**County of Nevada  
Information & General Services Department  
Purchasing Division**

**ADDENDUM NO. 3 (Redesign)  
McCourtney Road Transfer Station  
(MRTS) Improvement Project**

**Addendum Release date: January 4, 2023**

1. Seven sheets have been modified for this addendum; Architectural pages 02A203, 02A302, 02A303, 02A504, and Structural pages 02S402, 03S103 and 03S302, and have been uploaded as two separate documents in Public Purchase

2 SCUPPER PLAN  
02A401 3" = 1'-0"

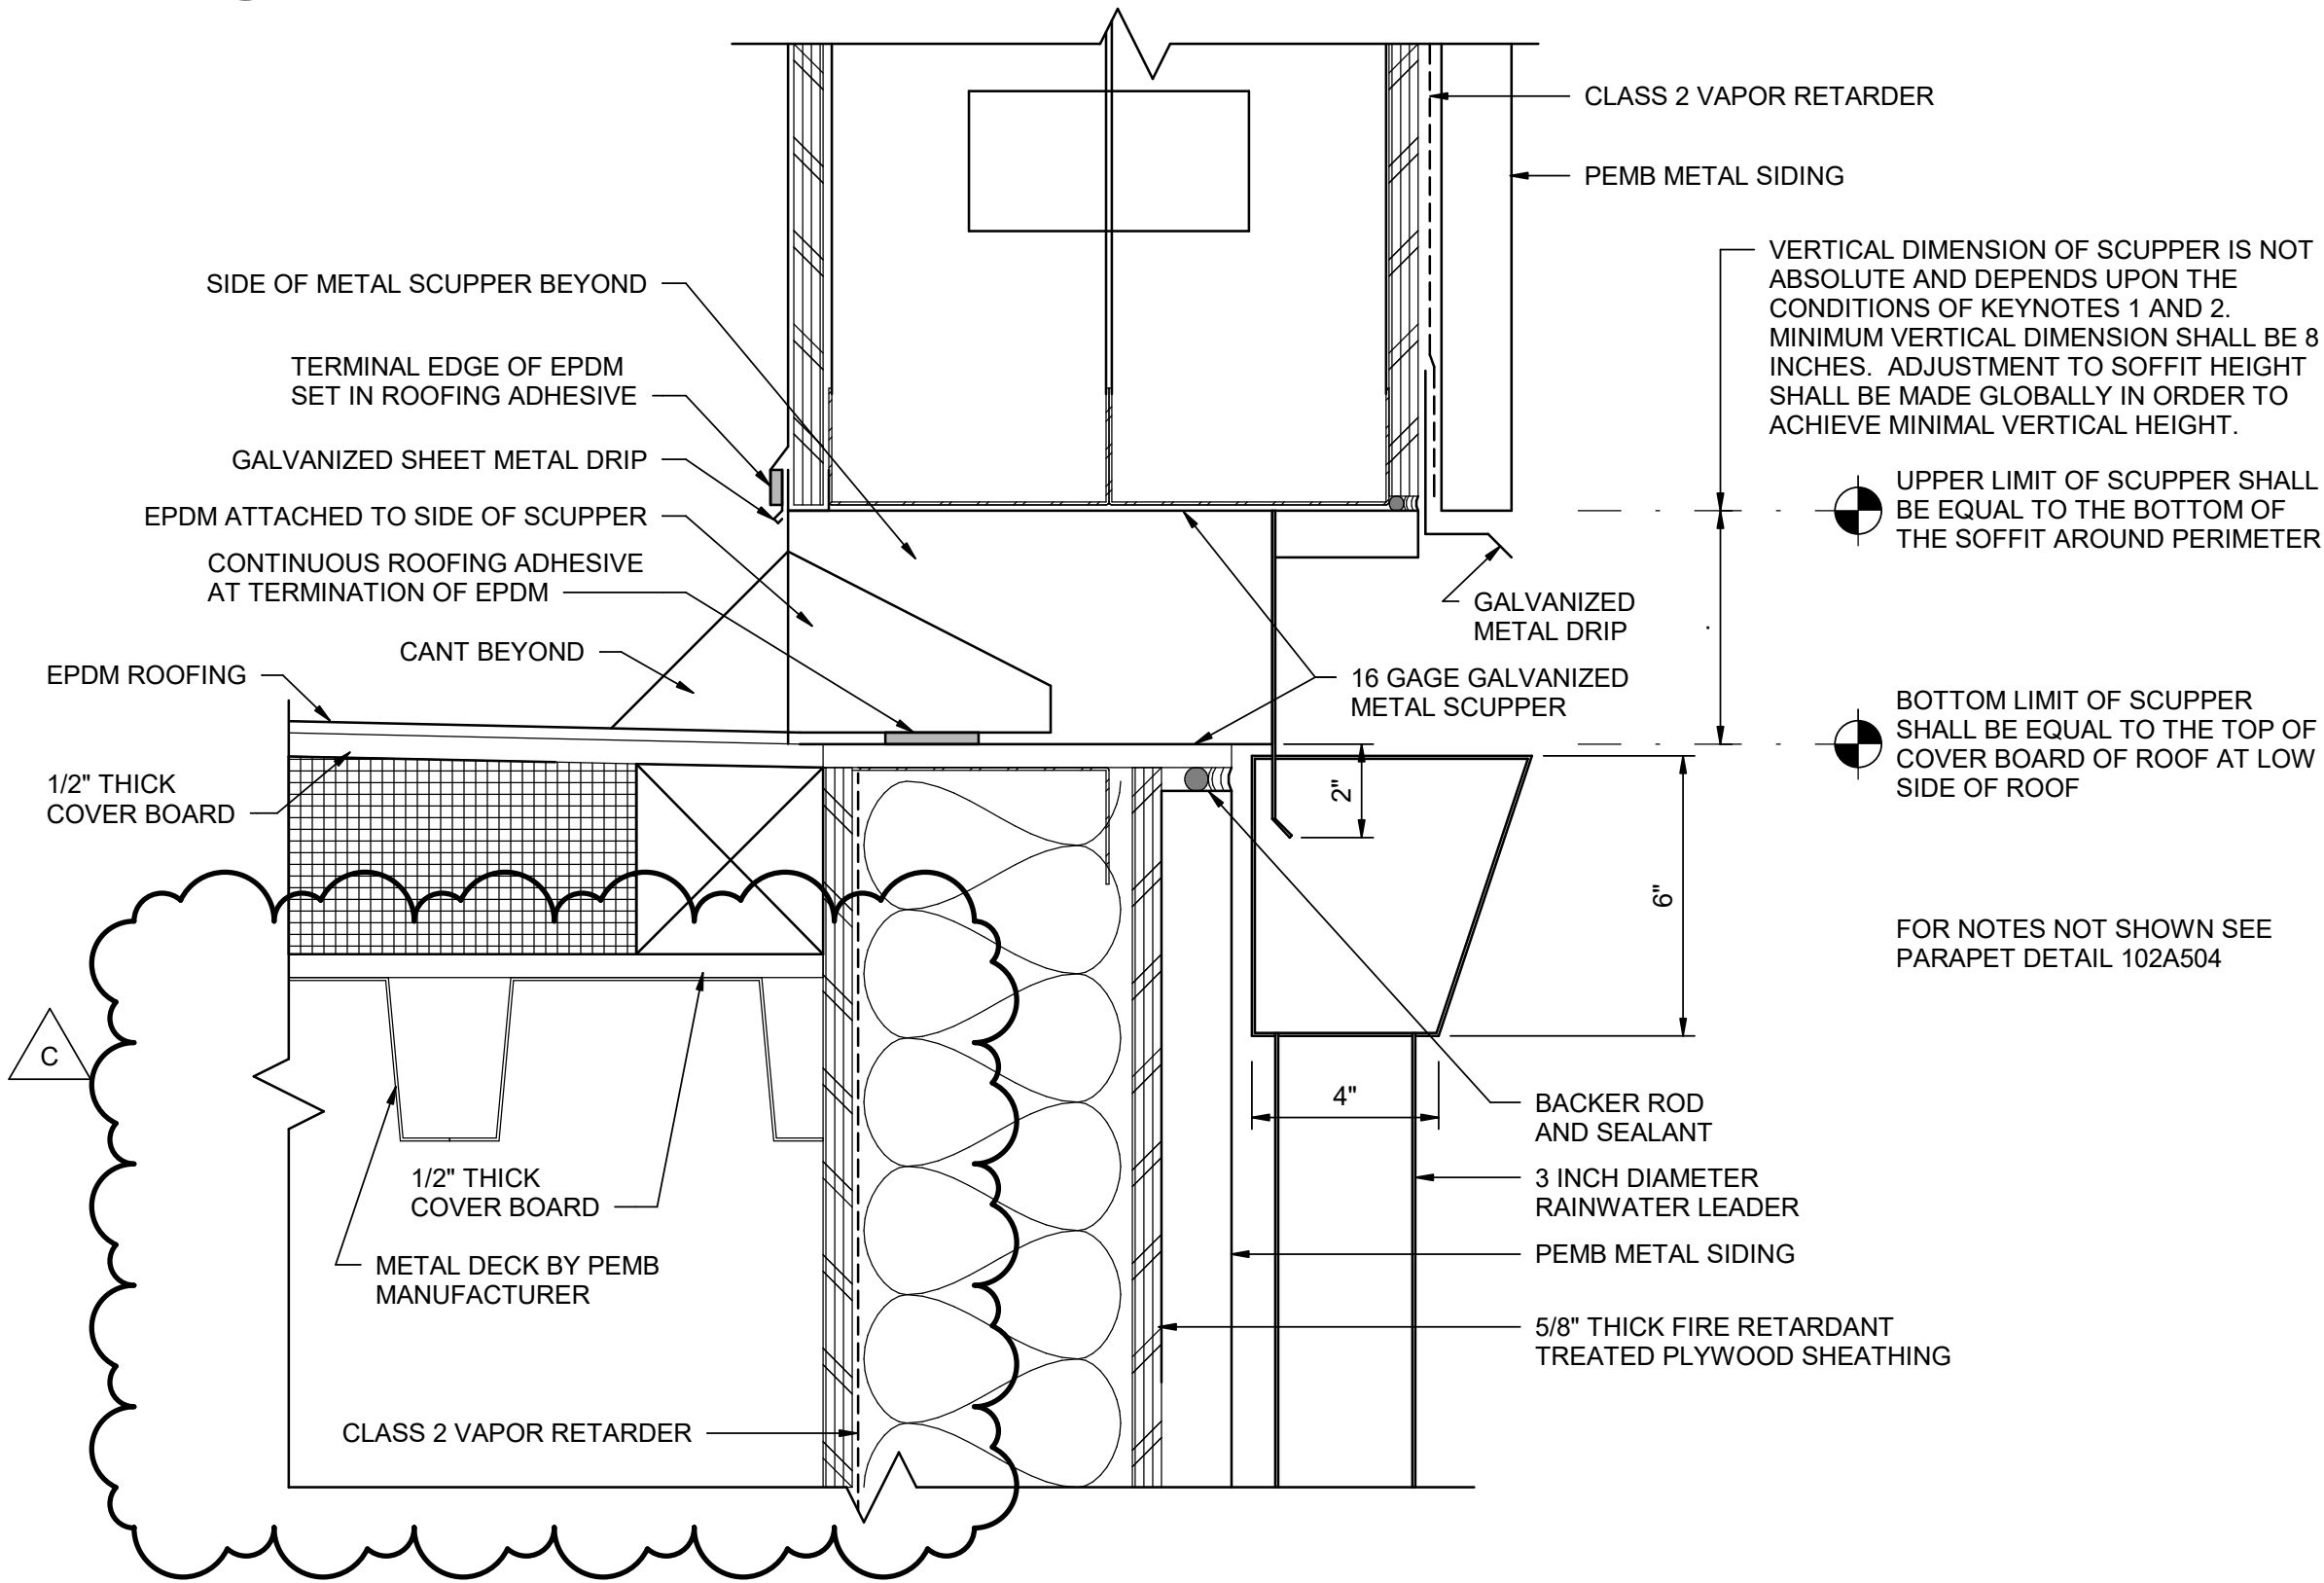
3.	<p>Reference 02A504 seems to call out plywood decking; 02S402 seems to call out metal roof decking. Q - Please clarify</p>	<p>The detail will be revised to show metal roof decking instead of plywood. In the essence of time, this response will suffice as acknowledging this clarification.</p>
